TO: Tasha Bolivar, Galloway and Company
FROM: Amber Wood Hicken, Planner I
DATE: 2/6/23
SUBJECT: Parker and Pine F1 L1 – In-n-Out Burger, Site Plan
Review Comments 01

Staff Comments 01
SP22-143; Parker and Pine
In-n-Out; Site plan
2/6/23

IN-N-OUT BURGER
SITE PLAN
PARKER & PINE FILING NO. 1, LOT 1
PARKER, CO 80134

SP1.0
Sheet 3 of 12

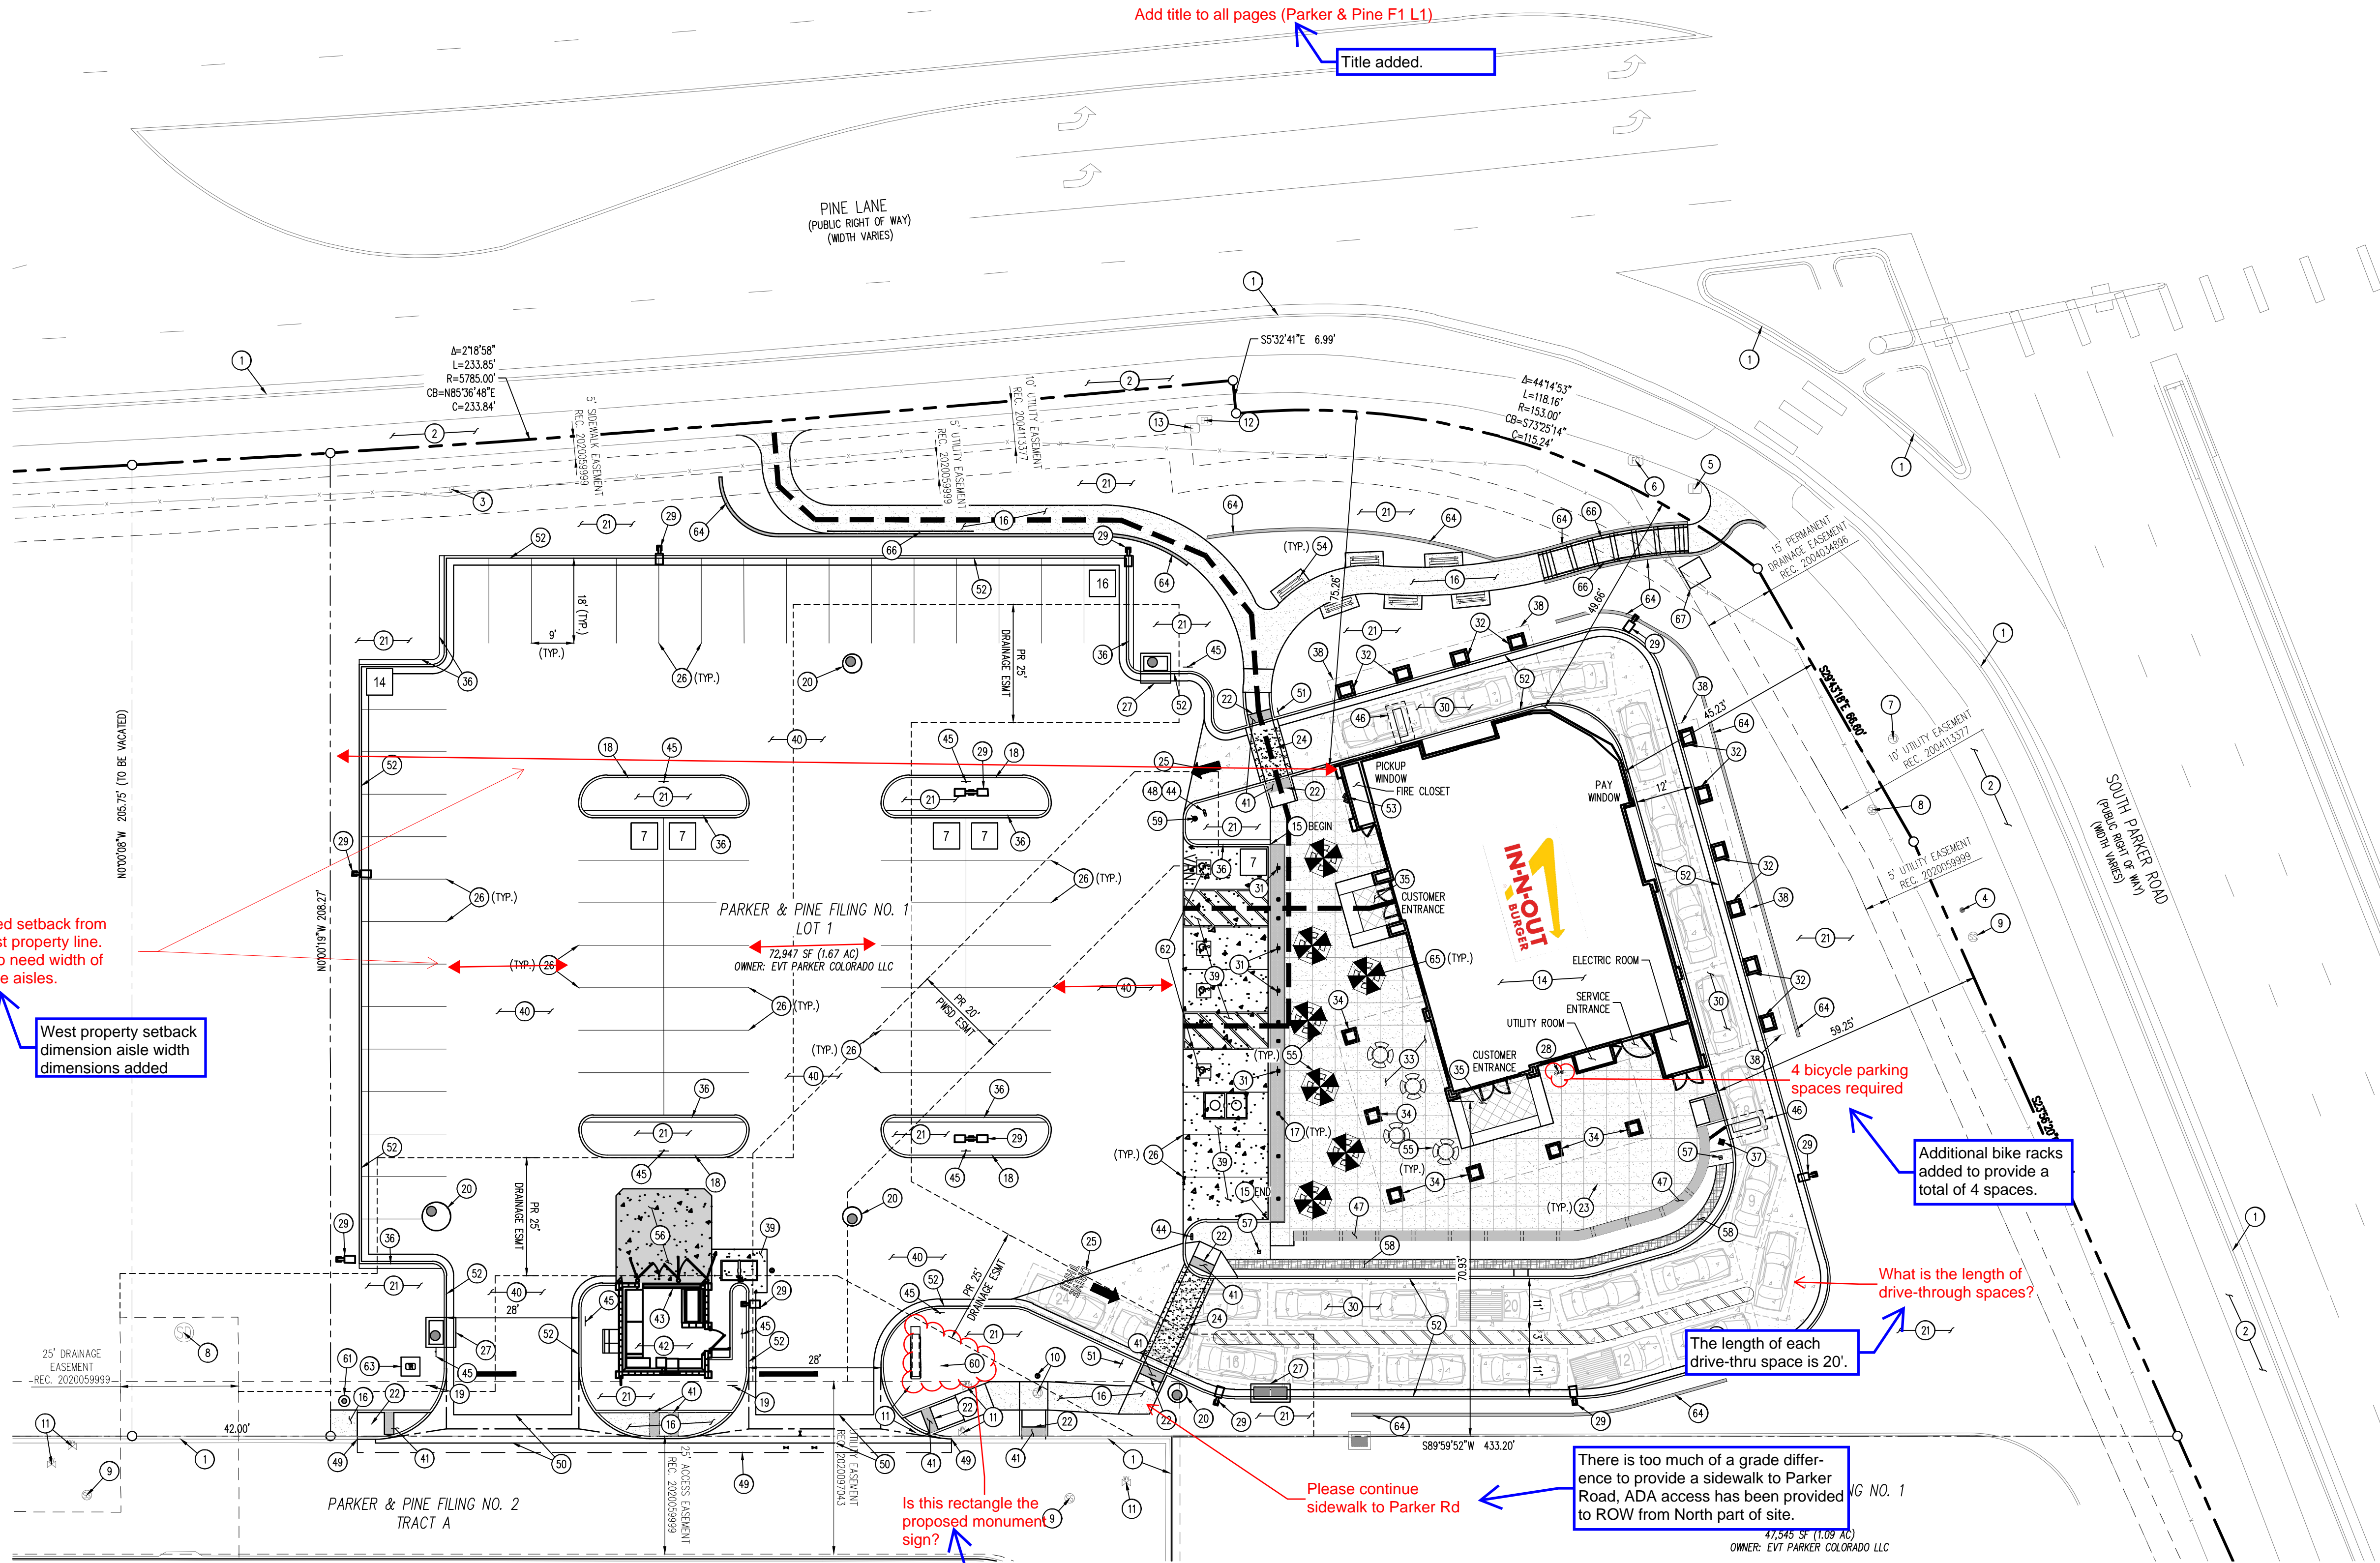
Add title to all pages (Parker & Pine F1 L1)

Need setback from west property line. Also need width of drive aisles.

4 bicycle parking spaces required

What is the length of drive-through spaces?

Is this rectangle the proposed monument sign?

Please continue sidewalk to Parker Rd

Need grading plan included as part of the Site Plan set showing the height of the wall along with the materials and colors.

Title added.

West property setback dimension aisle width dimensions added

Additional bike racks added to provide a total of 4 spaces.

The length of each drive-thru space is 20'.

There is too much of a grade difference to provide a sidewalk to Parker Road. ADA access has been provided to ROW from North part of site.

Grading plan added to site plan set with wall information.

SOUTH ELEVATION

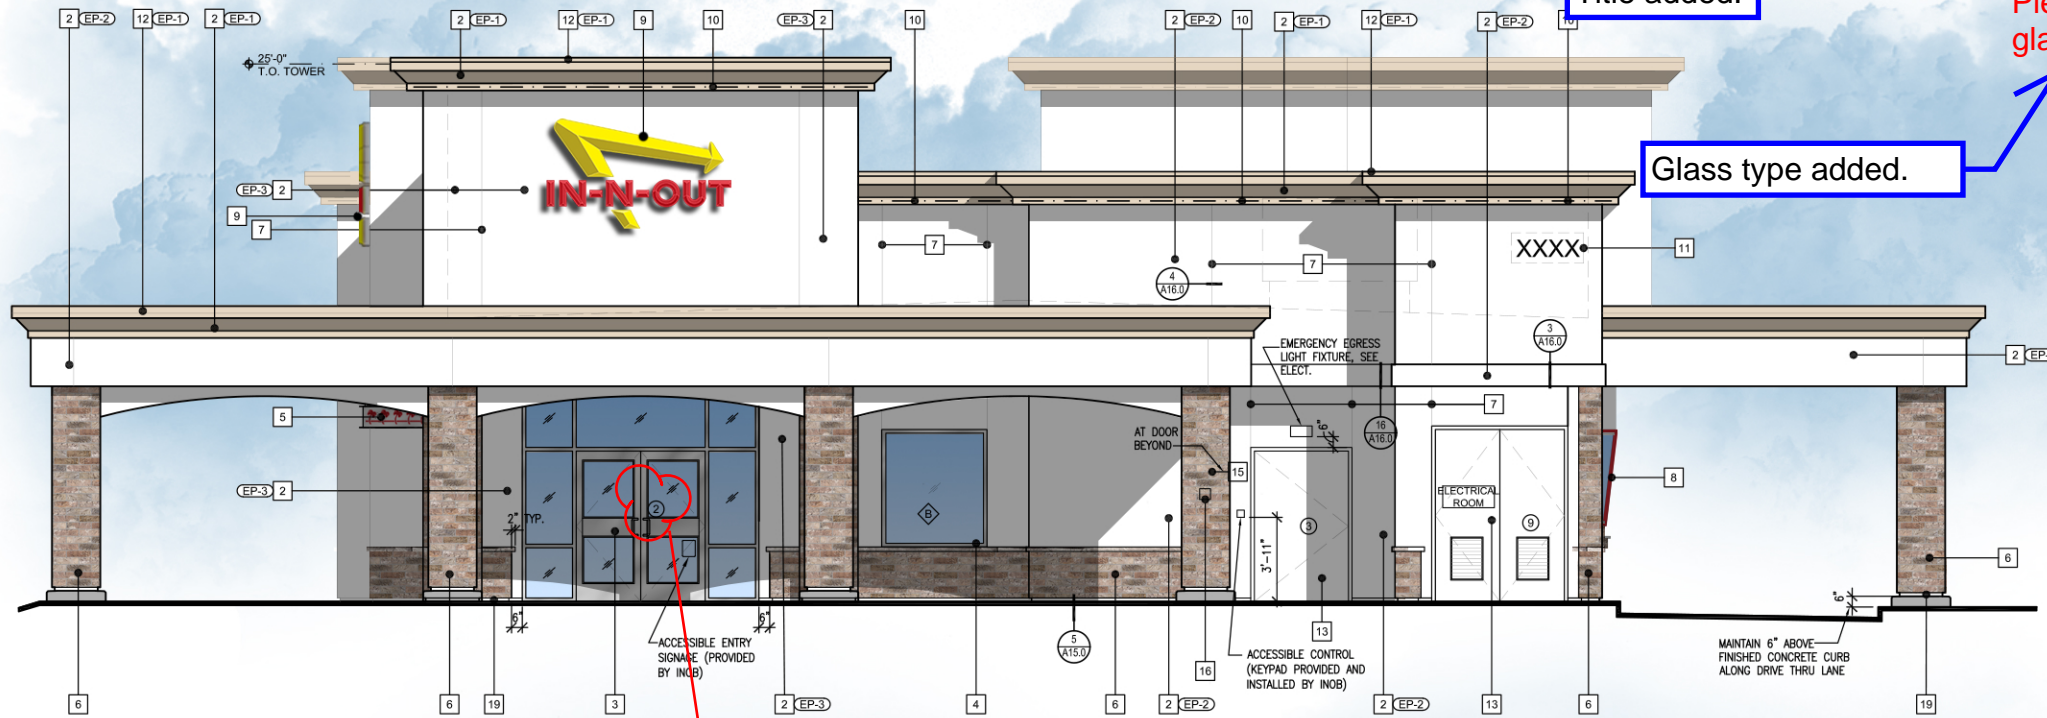
All blue clouded areas, please provide images with colors and materials.

Add title to all pages (Parker & Pine F1L1)

Please callout type of glass

Site Planning detail added for all bubbled items, with images as necessary.

Title added.

Glass type added.

WEST ELEVATION

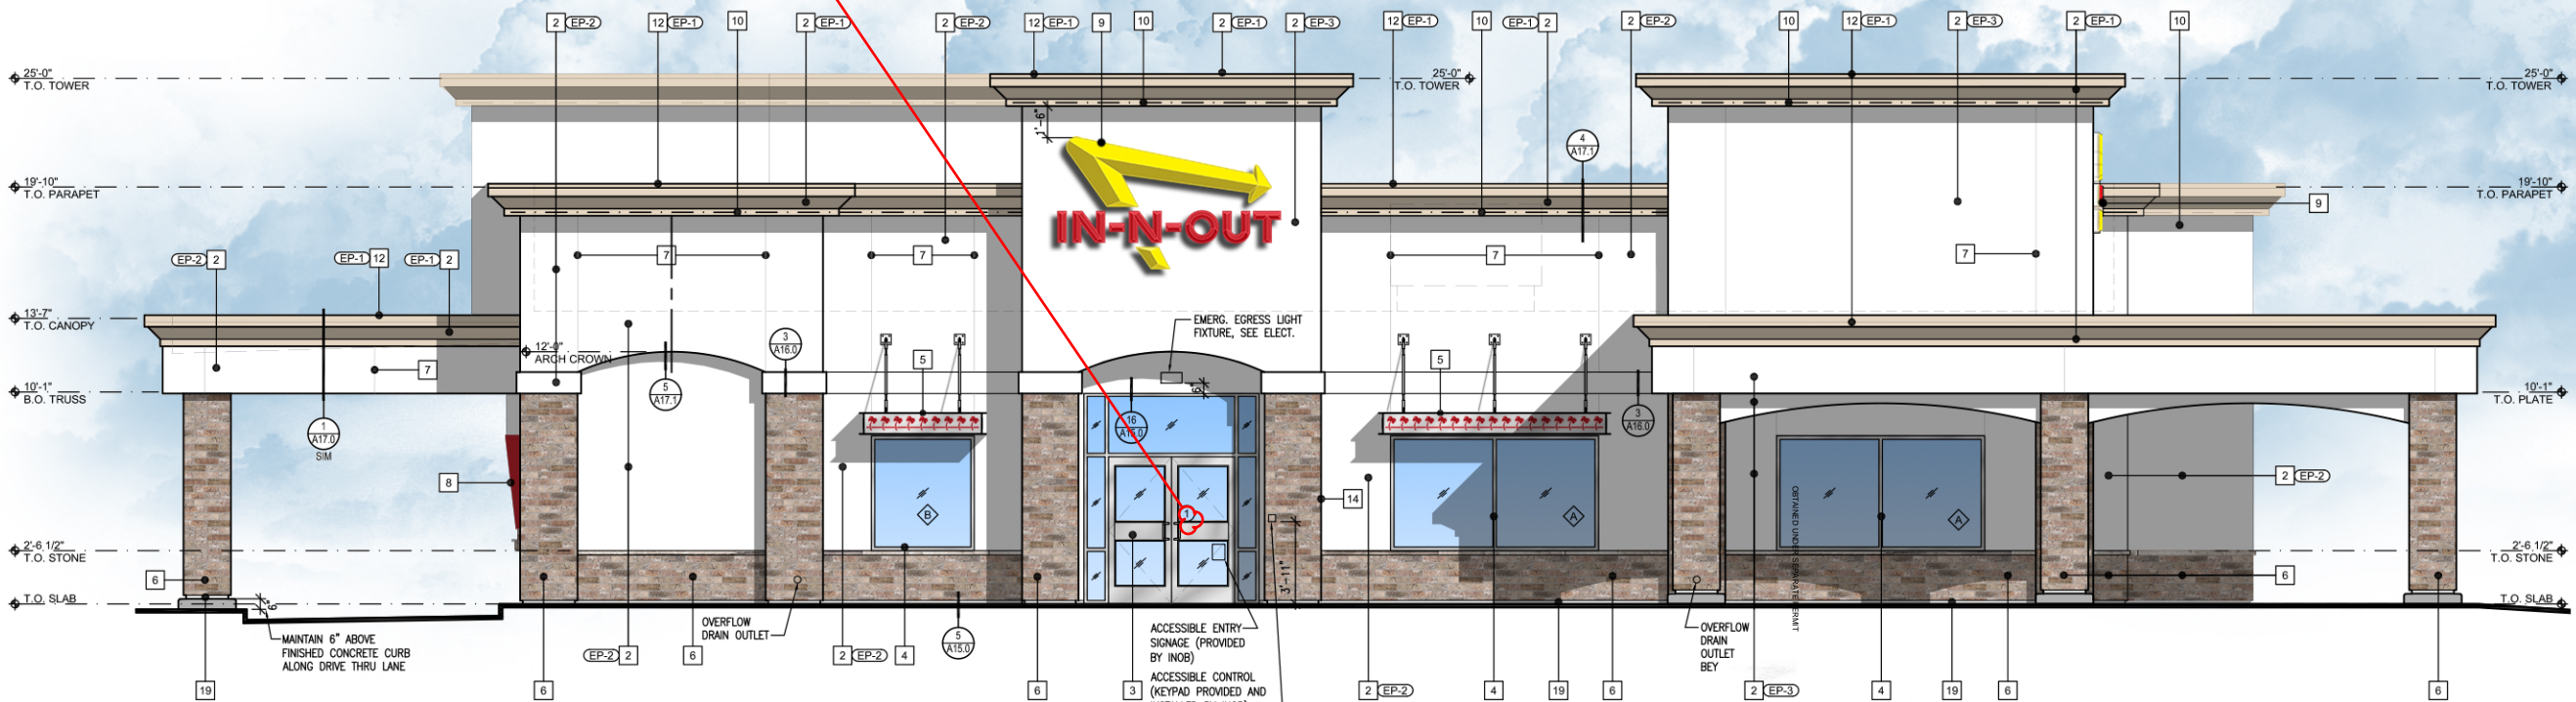
What is this callout?

Please provide vertical massing info (i.e., how far does canopy come out?)

Callout removed.

Vertical massing info added

NORTH ELEVATION

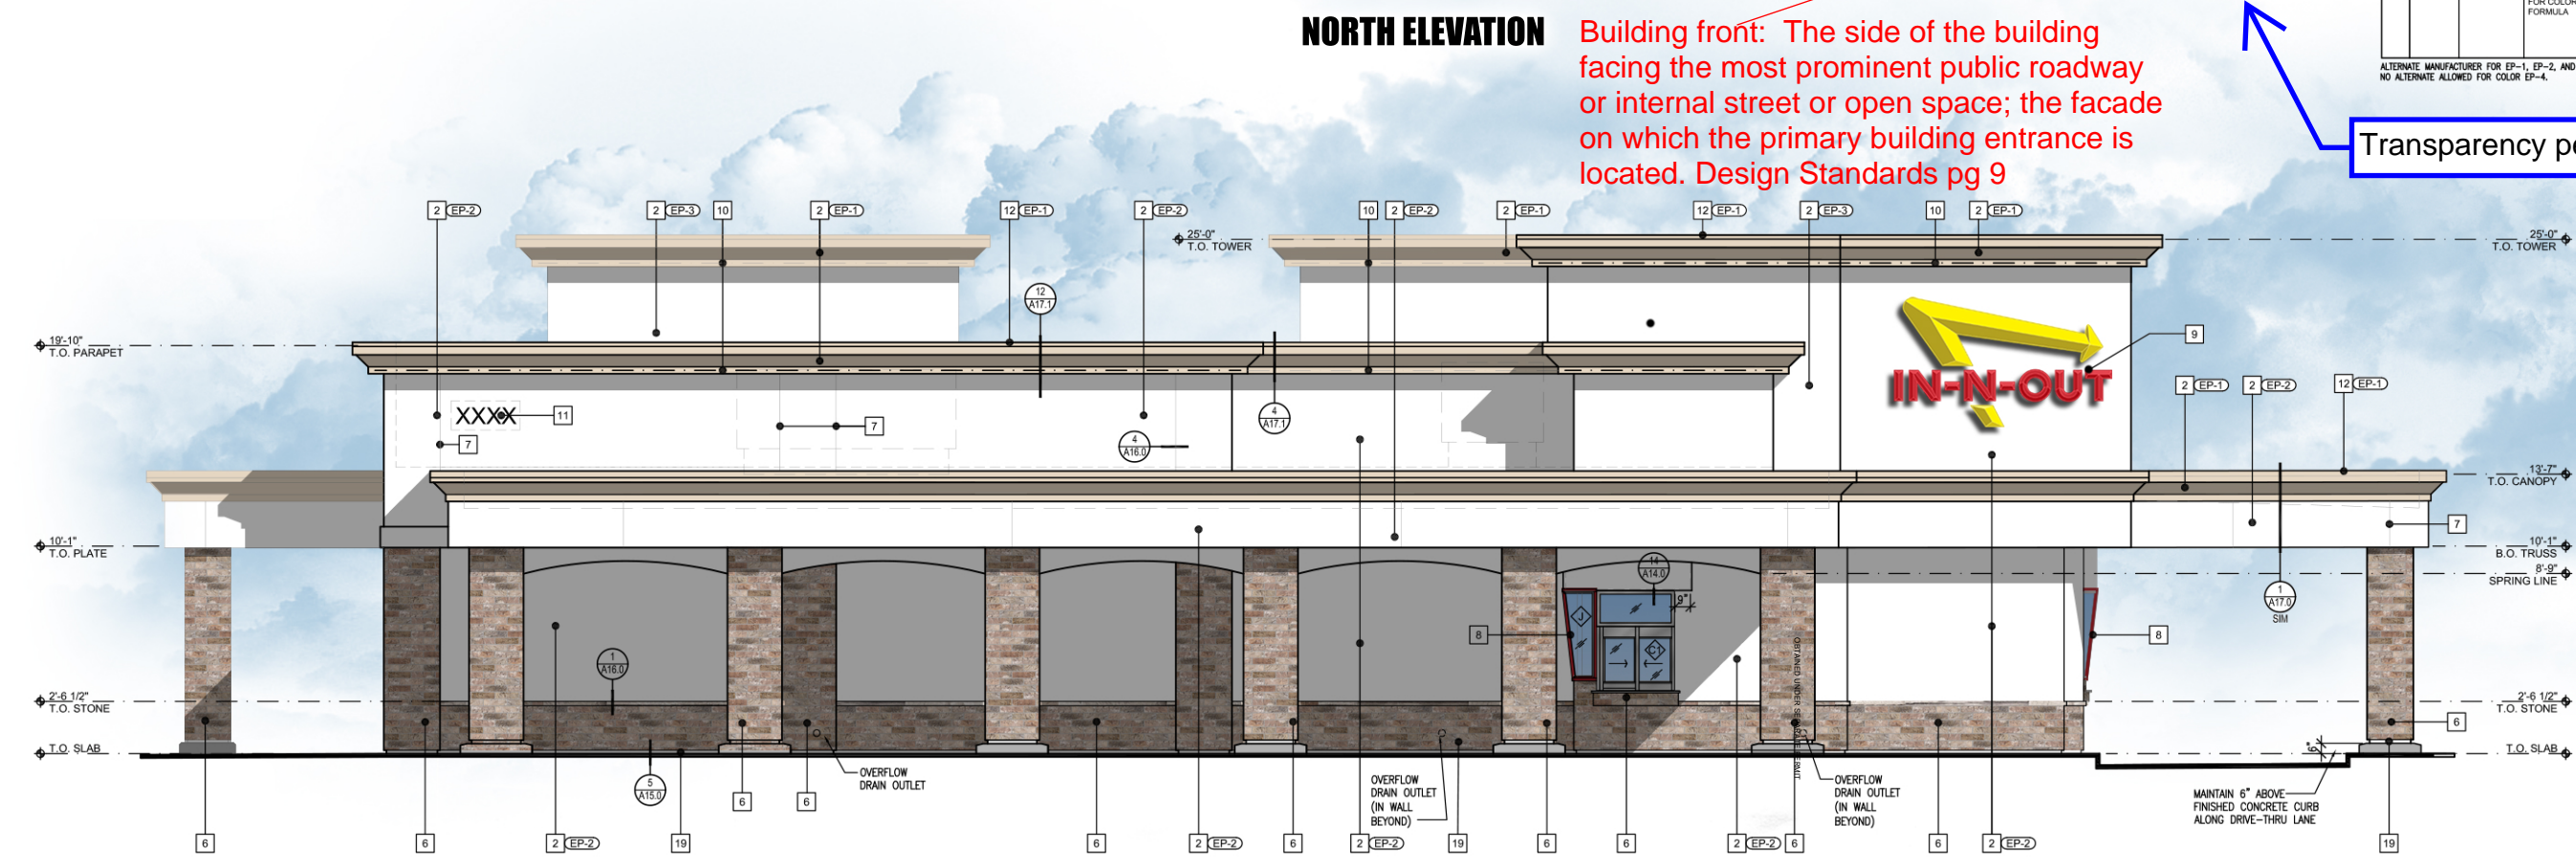
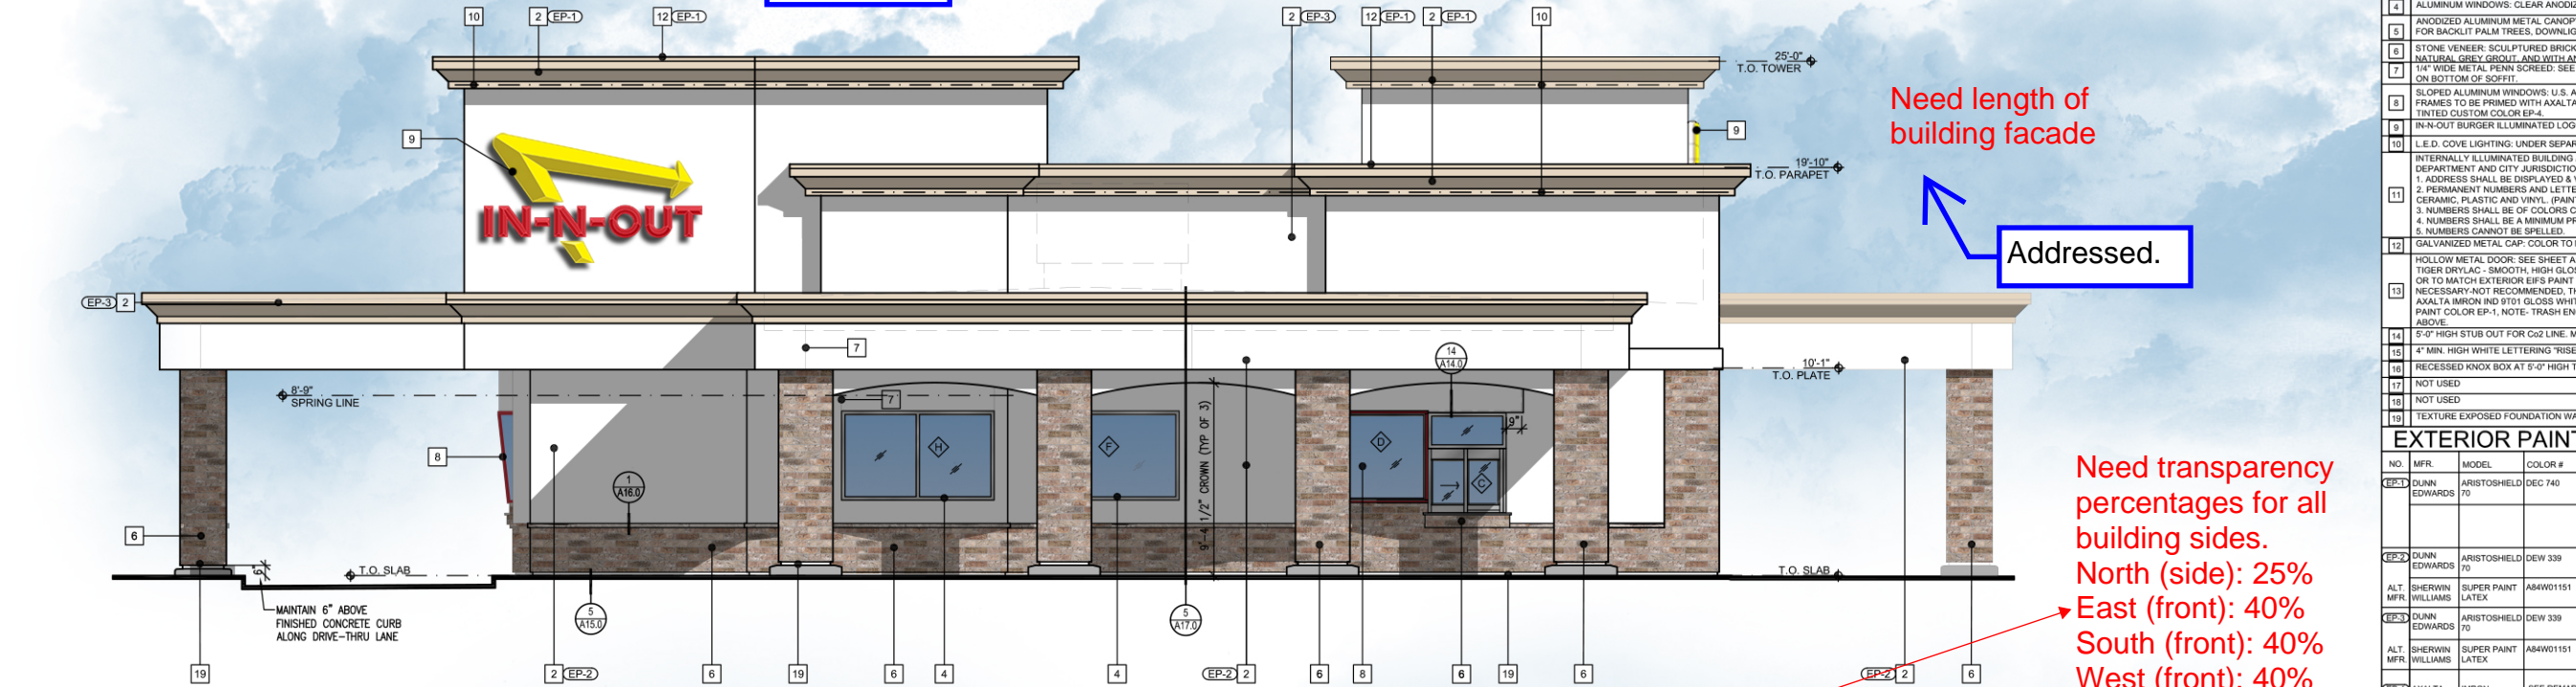
Add title to all pages (Parker & Pine F1 L1)

Need length of building facade

Need transparency percentages for all building sides.
 North (side): 25%
 East (front): 40%
 South (front): 40%
 West (front): 40%

Building front: The side of the building facing the most prominent public roadway or internal street or open space; the facade on which the primary building entrance is located. Design Standards pg 9

Title added.

Addressed.

Transparency percentages added.
